**Re: Draft Three Capes Track Development Proposal and Environmental Management Plan 2011**

**DRAFT DEVELOPMENT PROPOSAL AND ENVIRONMENTAL MANAGEMENT PLAN:  
THREE CAPES TRACK PROPOSAL, TASMAN NATIONAL PARK  
- IDENTIFIED ISSUES**

Tasmanian National Parks Association

23 December 2011

Figure 3. Mapping of wildness quality within the Tasman Peninsula. (Source: National Wilderness Inventory, Environment Australia).

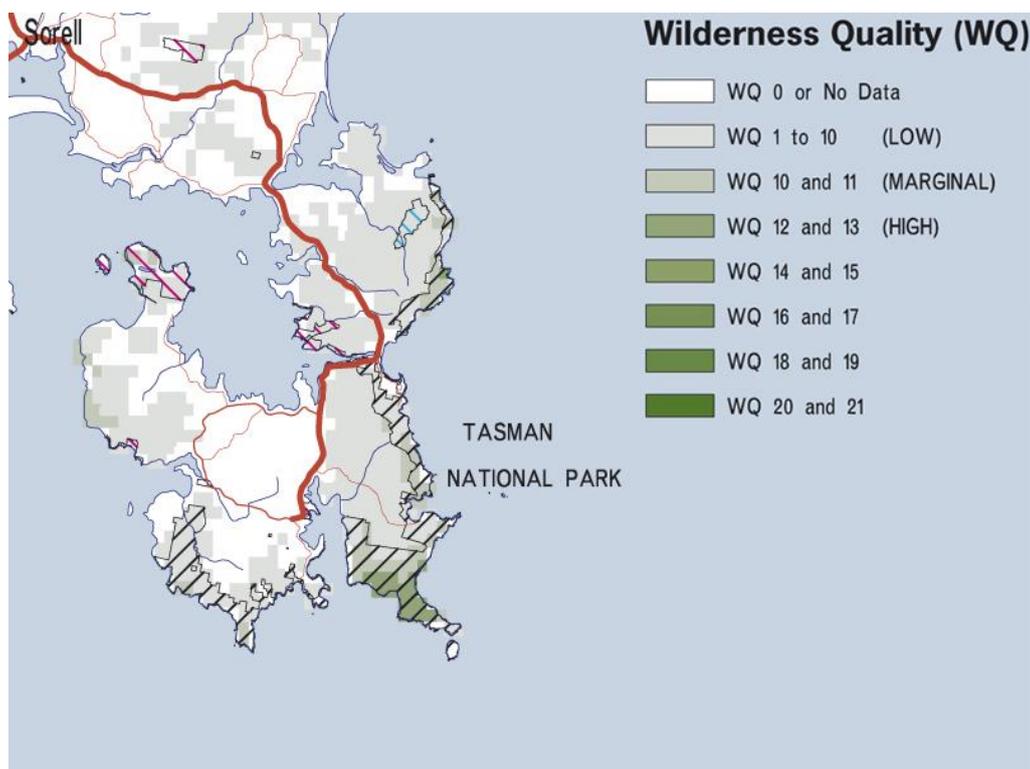
A mapping of wilderness quality within the Tasman Peninsula is shown in Figure 3 (on the next page). This assessment, undertaken during the 1995 RFA using the National Wilderness Inventory (NWI) methodology, shows an area of high quality wilderness (defined by the RFA as wilderness quality >12) on the Cape Pillar Peninsula. The overnight node complex proposed for a site above Lunchtime Creek is located within this high quality wilderness zone (itself in an area having a wilderness quality rating of 13-14) and as such would have a significant degrading affect on the wilderness value of this zone, the only remaining area of high quality wilderness on Tasman Peninsula. The same can also be stated for the highly designed track (or over-engineered footpath) through this region together with the large number of walkers that it is designed to bring. The overnight node at Retakunna Creek, being just outside this high quality wilderness zone and itself in an area with a wilderness quality rating of 10-12, will also have a degrading impact the wilderness quality of the area. Furthermore, the proposed track is very extensive (in effect running the length of the Tasman National Park), hence leaving no part of the narrow coastal corridor that comprises the Park unaffected.

Given the clearly stated objectives of both the National Parks and Reserves Management Act 2002 and the Tasmanian Reserve Management Code of Practice to i) preserve the natural, primitive and remote character of wilderness areas, and ii) avoid activities in areas of high quality wilderness that could detract from the wilderness quality, the proposed Three Capes Track is clearly in breach of these objectives. Wilderness (or wildness) is a diminishing resource which needs to be protected.
